NJ Department of Environmental Protection
Division of Land Use Regulation
P.O. Box 420, Code 501-02A
Trenton, NJ 08625
Attn: Township of Neptune Supervisor

RE: NJDEP CAFRA INDIVIDUAL PERMIT
Block 101, Lot(s): 3 & 4, Parts of Lot 2 and 5 and
End of Beach Avenue
NJ DEP File No. 1334-04-007.2; LUP200001

Photo 9

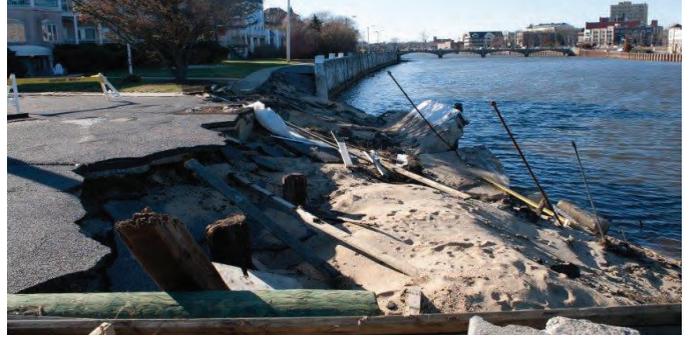
OGHOA does not have the technical expertise and information to address these statements, but see the photographs of damage to the Wesley Lake wall, near the southeast border of the site, as a result of Super Storm Sandy. Photographs 9 and 10, attached.
